# Service Bulletin

| <b>Subject:</b><br>CHIRP NOISE FROM RIGHT REAR AT 60 MPH OR MORE | <b>Bulletin No:</b> 09-001/13  |

2013-2014 CX-5 vehicles with VINs lower than JM3KE\*\*\*\*\*358081 (produced June 3, 2013)

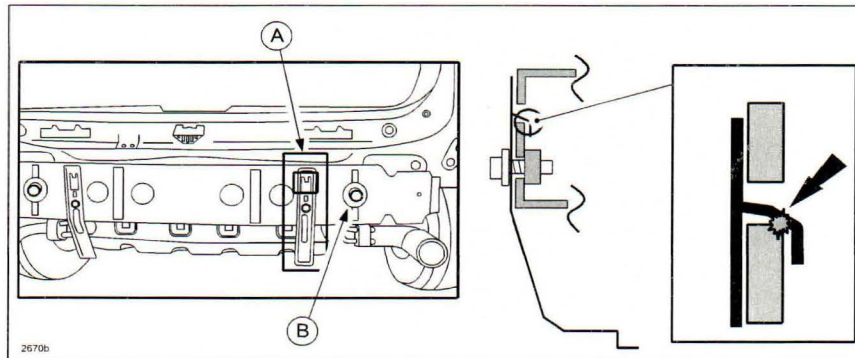
The chirp noise may be caused by the right side rear bumper stay hook (A) contacting the bumper reinforcement (B) at high speed. The shape of the reinforcement hole has been changed on both sides to eliminate the noise. Also, pads have been added to the bumper stay to prevent contact noise.

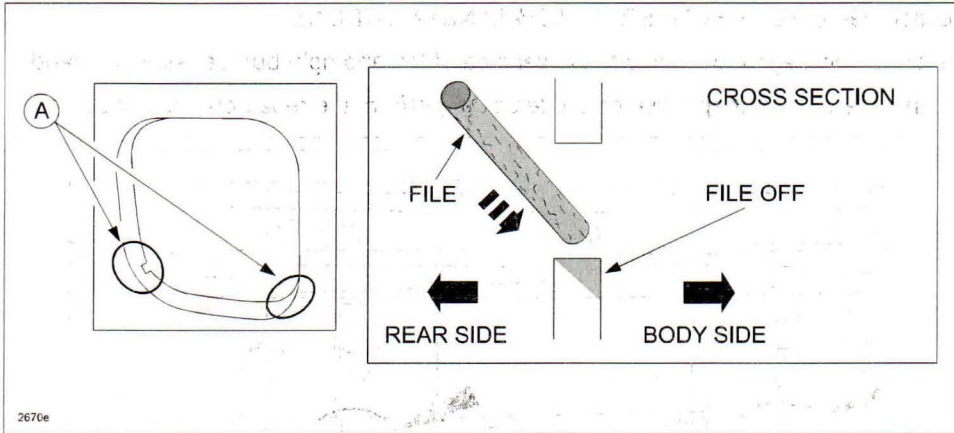
6. File off the inside of both lower hole corners (A) as shown below.

- File off the shaded area until there is no contact between the bumper stay hook and bumper reinforcement.
- Clean the area with an air hose.

7. After cleaning the filed areas, apply touch-up paint to prevent rust.

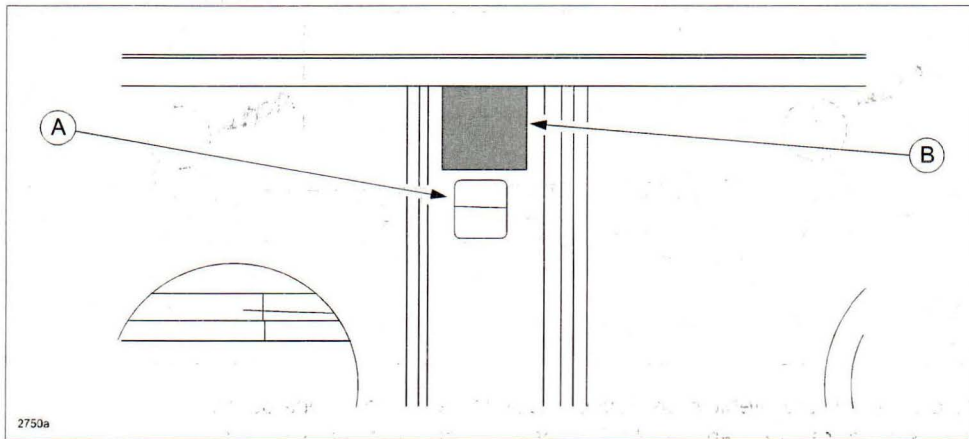
9. Apply (1) one 20 x 20mm pad (B) along the upper edge of the bumper reinforcement, above the hole for hook (A). Repeat Step 9 on the opposite side of vehicle.

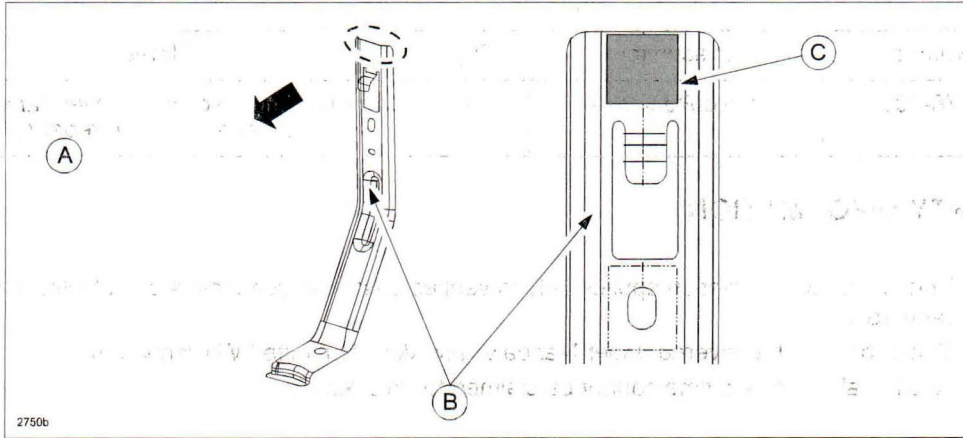
10. (a) Apply (2) two 20 x 20mm pads (C) on the front side of each bumper reinforcement (A), at the upper part of the bumper stay (B).

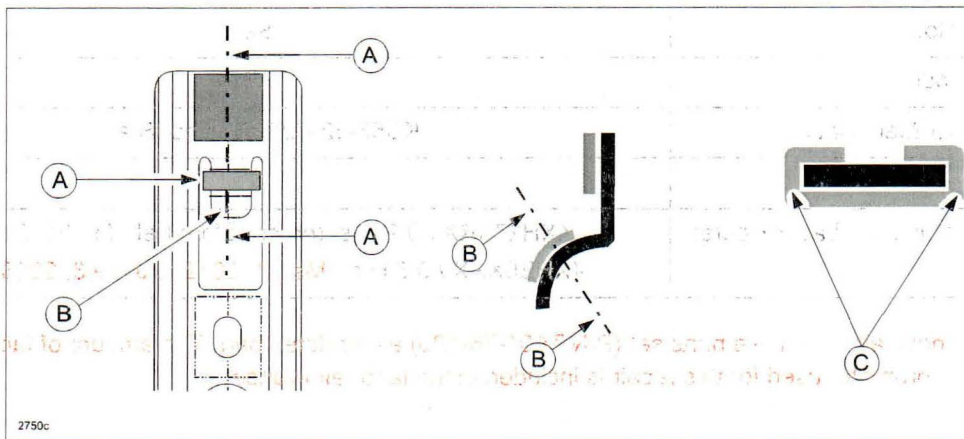
- (b) Apply (2) two 20 x 10mm pads (A) on the hook (B) of bumper stay. Wrap the pad (C) around both edges of the hook.
